ACOUSTIC DESIGN REVIEW AND NOISE
IMPACT ASSESSMENT OF PROPOSED
GYM TO BASEMENT

MARINE ICES, HAVERSTOCK HILL, CHALK
FARM, LONDON NW7 2BL

Our Ref HA/AB795/V1
Site Address Marine Ices, Haverstock Hill, Chalk Farm, London NW3 2BL
For Incyon Ltd
Client Address 29 Lawrence Avenue, London NW7 4NL
Date of Report 13 January 2020
Author Mr Leo Hawkins PGdip (IOA) BSC (Hons) AMIOA
Checked by Mr Stuart J G Nixon MSc BSc (Hons) MIOA MCIEH

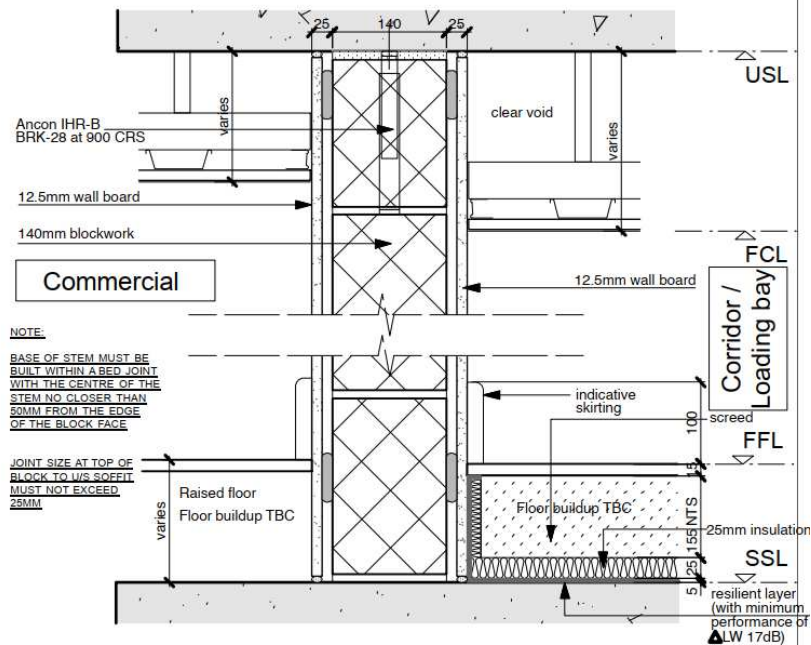
6.2. The proposed external façade build-up is presented below, as laid out in architectural drawing dE05:

- 125mm Pile
- 250mm Reinforced Concrete Wall
- 20mm Newton 508 Tanking Membrane
- 100mm Blockwork

6.3. As the gym will be housed within the basement and therefore underground, the external facades do not need to be specified for airborne sound insulation performance, although it is important to ensure all joining sections between the walls and ceiling are isolated to ensure structural noise or vibration does not travel through the structure of the building itself (see recommendations in section 8 below).

8.2. The external facades do not present an immediate problem through airborne noise, though it is important that the external façade structure is isolated from other partitions to ensure structure borne vibrations and flanking paths are avoided.

8.3. The implementation of a floating floor within the gym would assist in reducing structure borne vibrations transferring into the external facades and other partitions, especially from the dropping of weights. An example construction of a suitable floating floor is laid out in Approved Document E section 3.65:

IWS-04 Partition Wall - 190mm

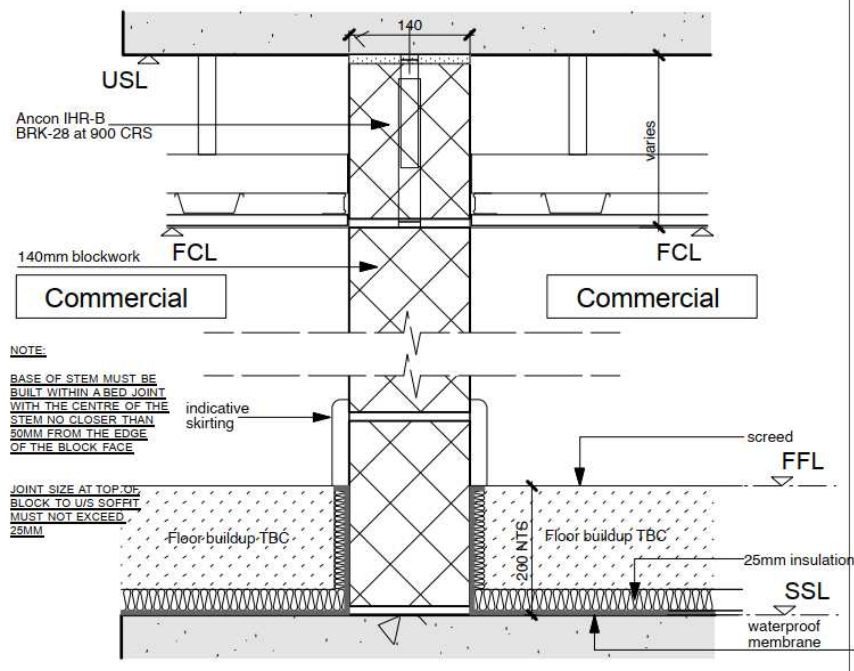
Predicted sound insulation performance: 47dB $R_w + C_{tr}$

7.6. The performance of the internal wall partitions could cause transmission of sound to the commercial premises on the ground floor due to airborne noise entering stairwells or via structure borne vibrations.

8.5. To reduce the potential noise break out into corridors and stairwells it is recommended that the corridor facing partitions are upgraded by including resilient bars with absorptive material placed within the cavity. An example construction is presented below:

- 12.5mm Soundbloc Plasterboard
- 12.5mm Dot and Dab Plasterboard Adhesive
- 140mm Blockwork

- 50mm x 45mm Timber Studs at 600mm centres
 - cavity infilled with Rockwool (40kg/m³)
- Resilient bars
- 2x 12.5mm Soundbloc Plasterboard

Predicted sound insulation performance: 58dB R_w + C_{tr}

IWS-04A Partition - 265mm

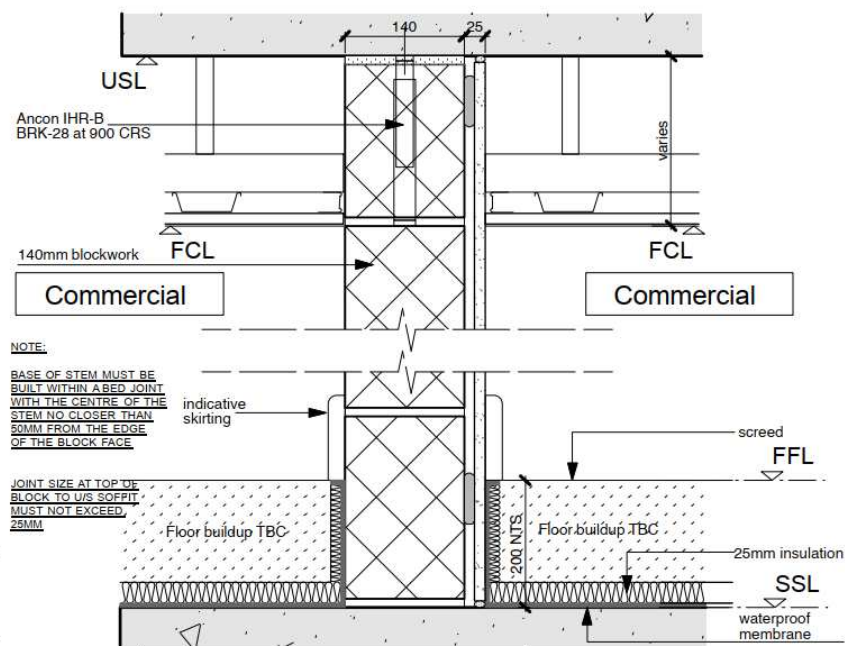
Predicted sound insulation performance: 47dB $R_w + C_{tr}$

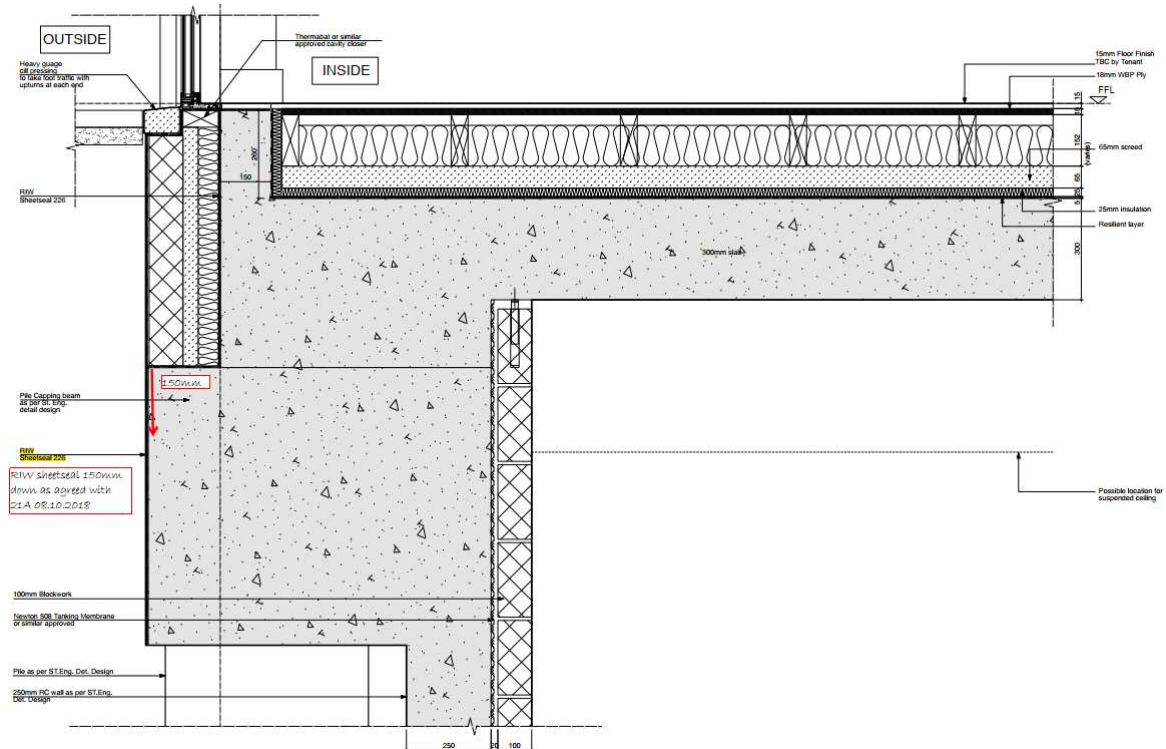
6.7. The proposed separating floor construction build-up is presented below and has been taken from architectural drawing dE04:

- 15mm Floor Finish (TBC by Tenant)
- 18mm WBP Ply
- *152 x 50mm Timber Frame at 500mm centres
- 65mm Screed
- 25mm Insulation
- 5mm Resilient Layer
- 300mm Concrete Slab

Predicted sound insulation performance: 49dB $R_w + C_{tr}$

*Frame material has not been specified within the drawings and has therefore been assumed.

7.5. The separating floor needs to be improved to ensure break-out noise does not negatively impact nearby receptors, as this is the most direct path for the sound to travel.

8.8. It is recommended that the separating floor is upgraded to improve the sound insulation performance, especially around 125Hz. The addition of a suspended ceiling should provide the required improvements. An example of a suitable floor build up is presented below:

- 15mm Floor Finish (TBC by Tenant)
- 18mm WBP Ply
- 152 x 50mm Timber Frame at 500mm centres
- 65mm Screed
- 25mm Insulation
- 5mm Resilient Layer
- 300mm Concrete Slab
- 300mm Suspended Light Steel Grid Ceiling
 - Cavity infilled with Rockwool (40kg/m³)
- 12.5mm Soundbloc Plasterboard

Predicted sound insulation performance: 76dB R_w + C_{tr}

IWS-02 Partition Wall - 100mm
1:5 @ A1, 1:10 @ A3

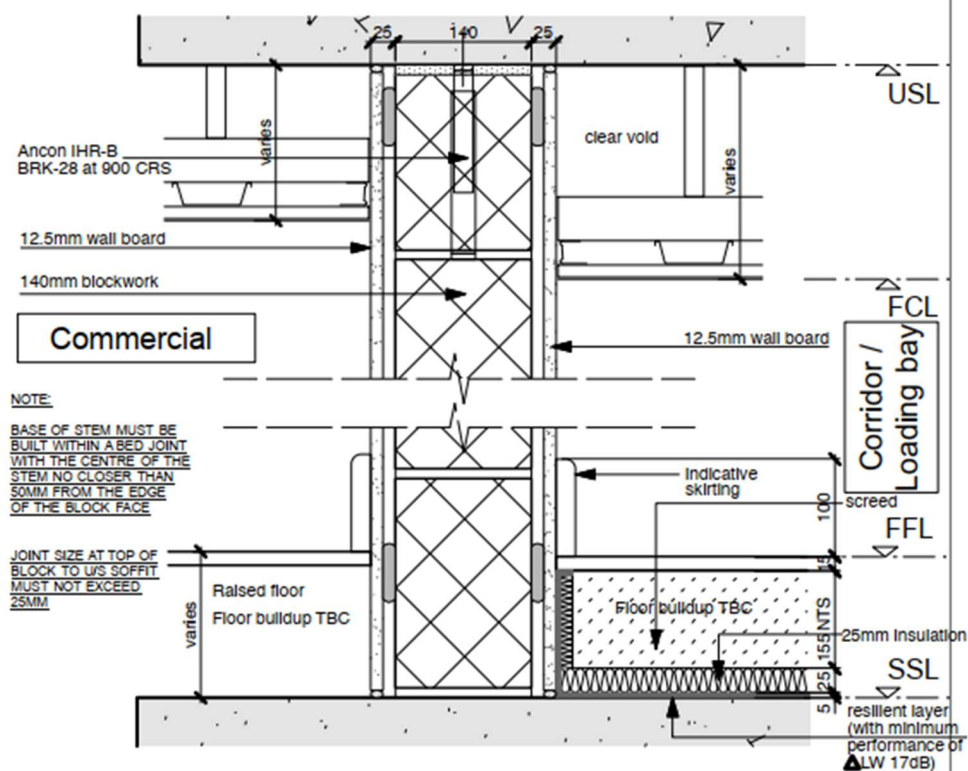
Predicted sound insulation performance: 47dB R_w + Ctr
